BLK LIVE - USER PERMIT
7301 E. BUTHERUS DRIVE
SCOTTSDALE, AZ 85024

SITE PLAN / REVISED PARKING CALCULATIONS

RE: BLK Live Conditional Use Permit - City Comment Response Letter
CUP #: (12-UP-2018)

DELTA 2 – CUP City Comment Responses

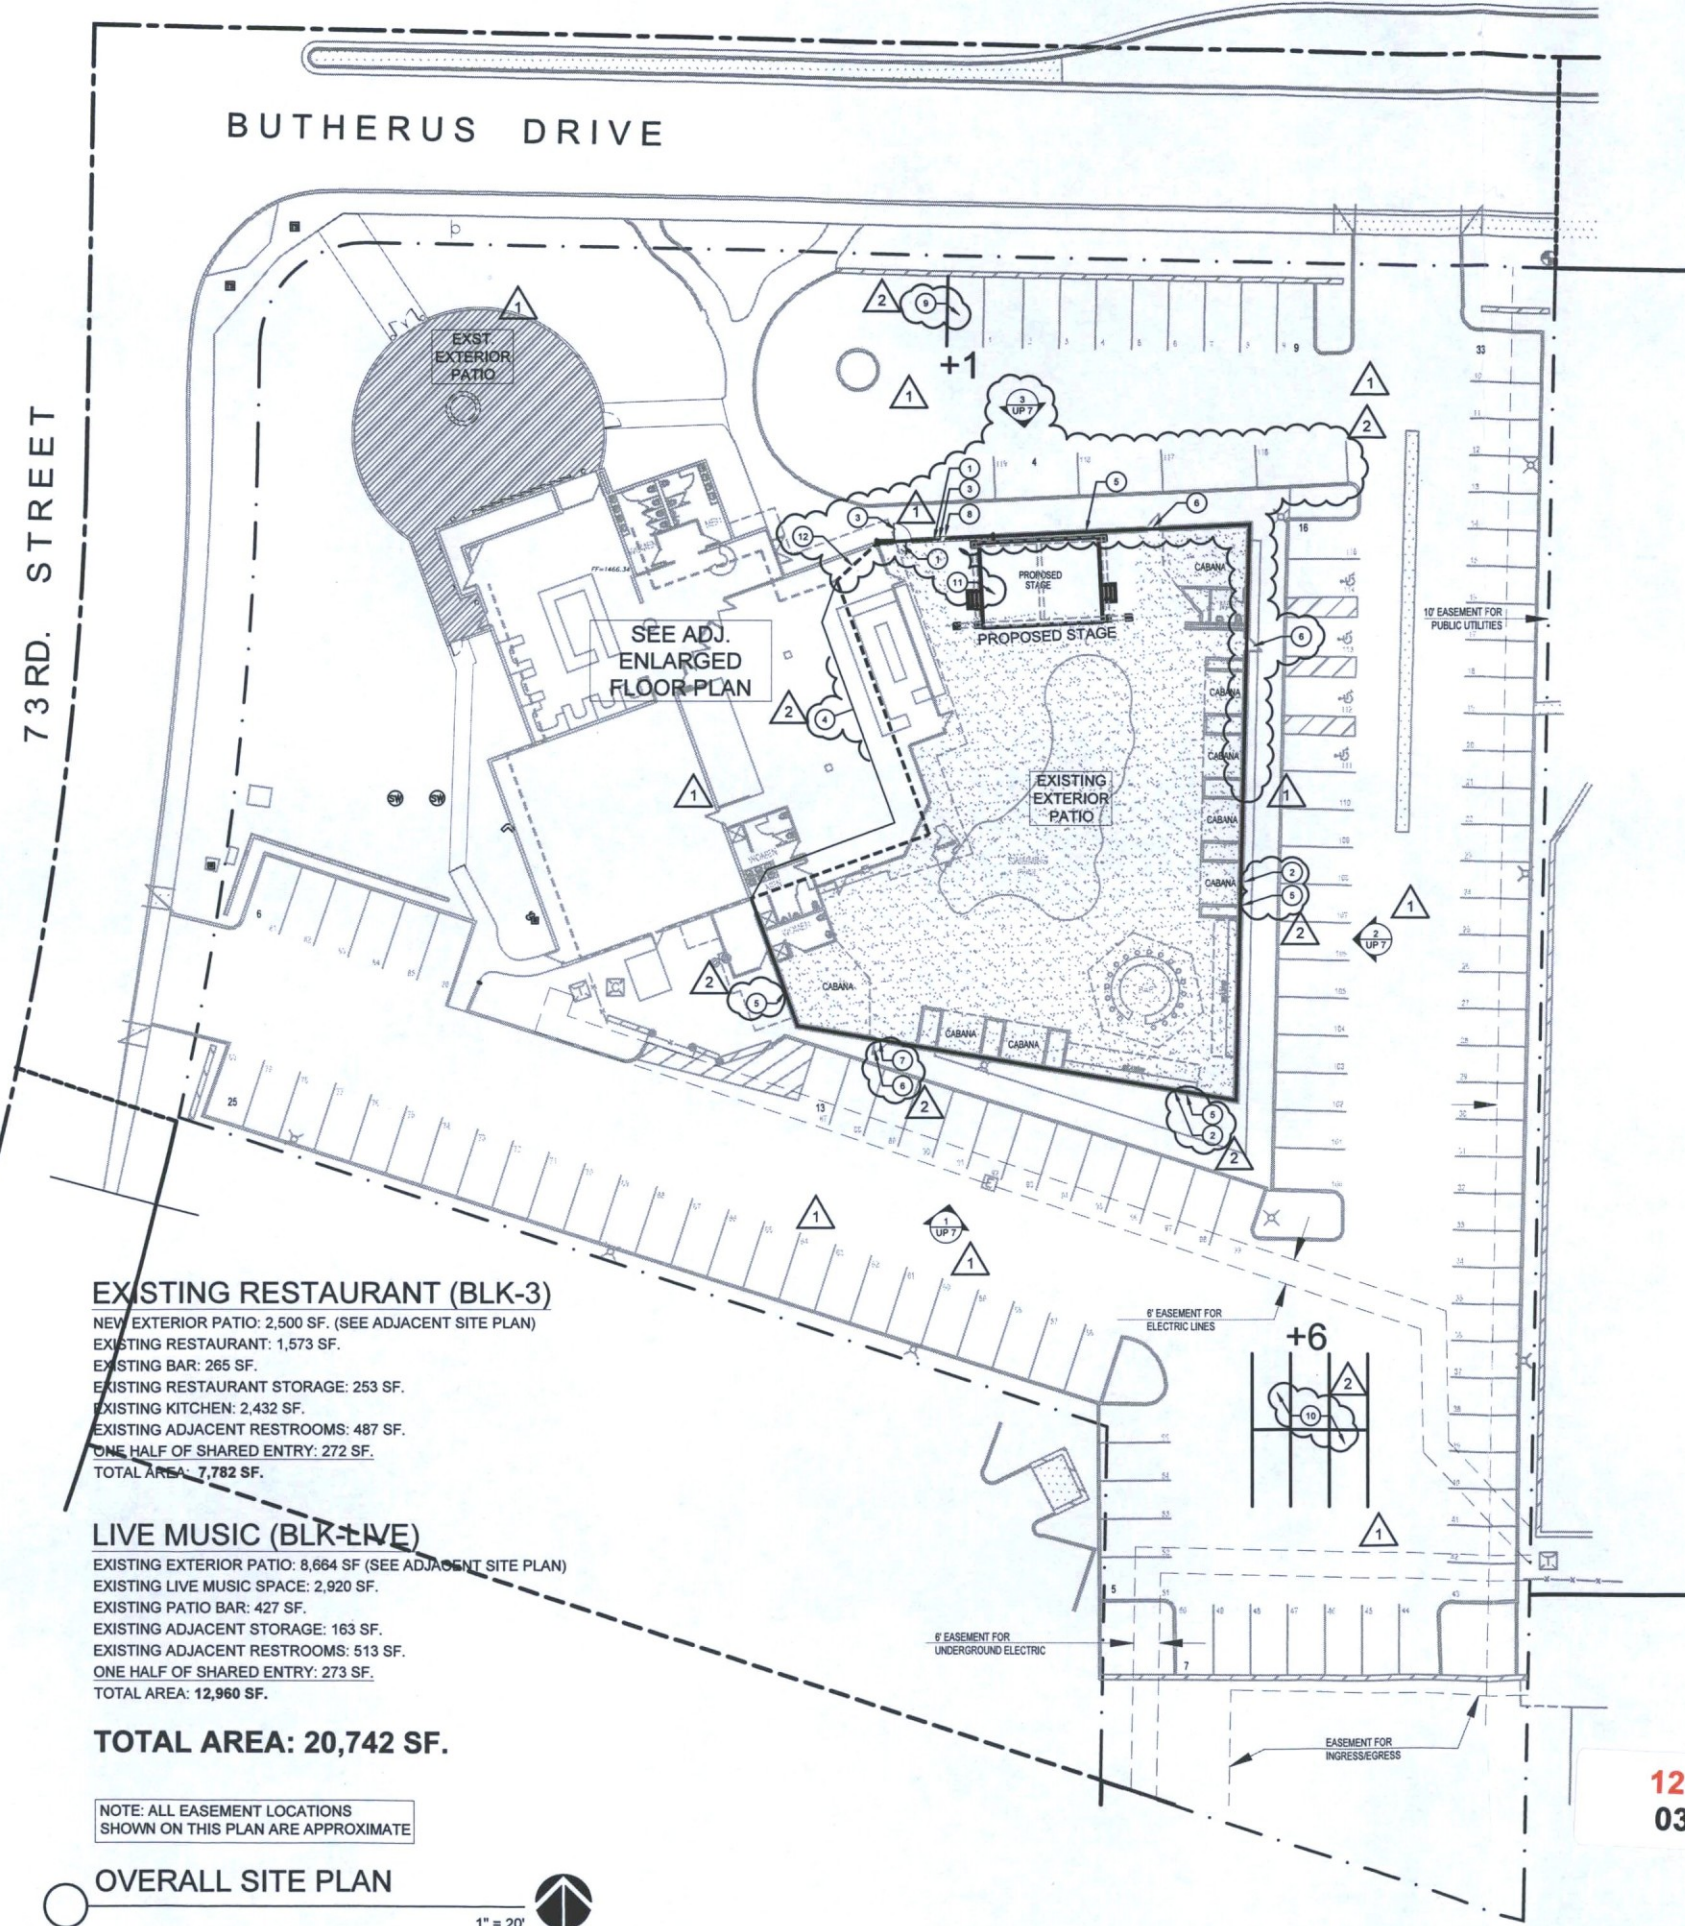
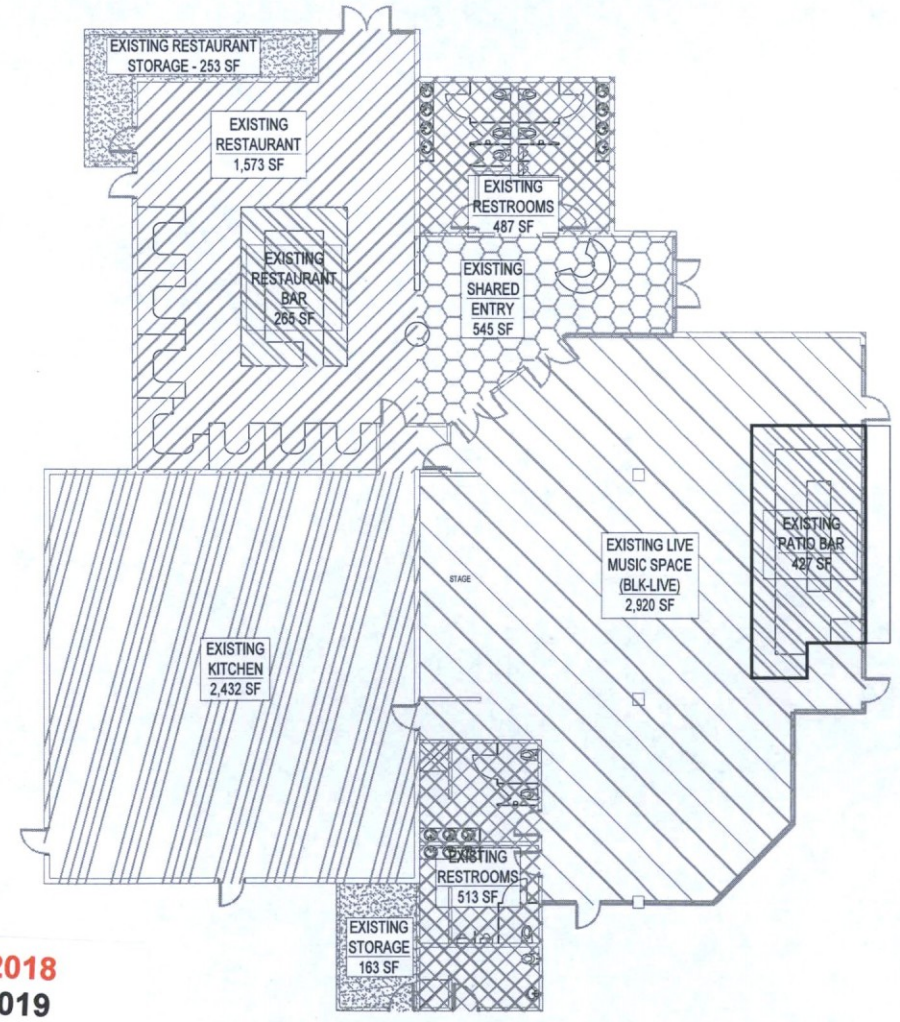
UP 1 SHEET

- 1) Parking quantity achieved. See revised parking calculations for all owned and leased stalls, quantities, and addresses. A total quantity of (138) stalls was deemed acceptable by Bryan Cluff, via email, on Tuesday, October 30th. See sheet (UP 7) for all locations on a map and distances between property lines.

- 2) The acoustical canopy is now shown going around the entire patio, along those sections of existing mechanical screen adjacent to the patio, and a short mechanical screen extension on the roof in the northwest corner of the patio per **citizen comment #9**.

- 3) To make this sheet easier to read I added site plan keynotes and removed the notes directly on the plan. Some new keynotes were added.
- 4) The new (8) angled stalls have been removed per **city comment #2**. Not changes to the (4) existing stalls here. Instead those (8) stalls have been leased from an adjacent property.

- 5) A sheet index was added to improve navigation through the set.

HOURS OF OPERATION FOR BAR + LIVE ENTERTAINMENT?

As noted above, the bar has been in operation as part of the initial operation of BLK Live. The site is adjacent to the Scottsdale Airport/Airpark. *THE NEW PATIO AREA IS NOT ARTICULATED TO*

Additionally, the bar at BLK Live has been in operation since 2011 and we are not aware of any issues related to the bar itself. *THE NEW PATIO AREA " "*
